**Historic District Review Committee  
Staff Report  
Date of Meeting: March 12, 2012  
CAPP 2012-0004  
Historic District: Goose Creek  
Project Planner: Lauren Murphy**

**CAPP 2012-0004: Robert and Jennifer McMaster, New Residential Construction in the Goose Creek Historic District. PIN # 455-30-2467**

Figure 1: Subject Property, Lot 5, Meadow View Farm Family Subdivision

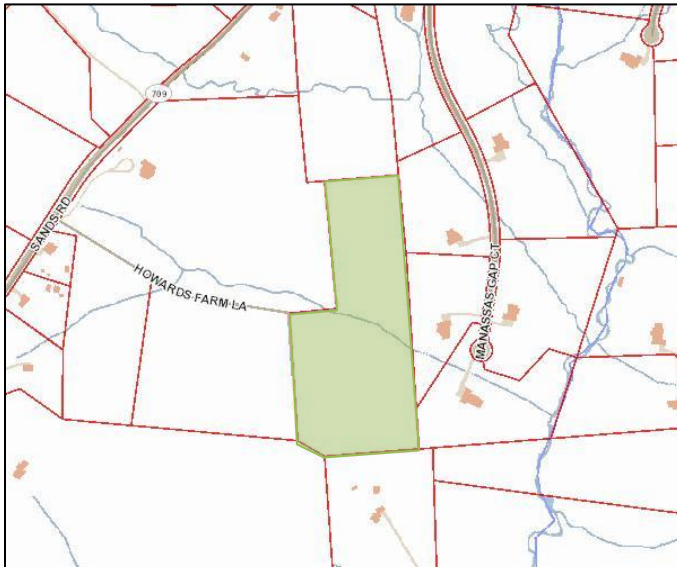
The subject property is approximately 10 acres located at the terminus of Howards Farm Lane (private road) which intersects with Sands Road. The subject property is located in the Meadow View Farm family subdivision. The HDRC approved a CAPP for lot 5 of this subdivision in 2002 (CAPP 2002-0016).
